Proposed footway expansion and segregated cycleways Broughton St to Canonmills

Spokes Response 22nd March 2021

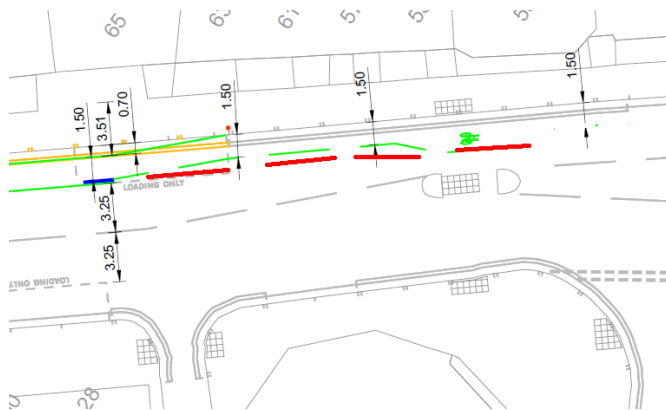
It is disappointing that the scheme does not include cycle segregation on the West side of Broughton Street and extremely disappointing that the segregation on the East side does not extend to the top of the street.
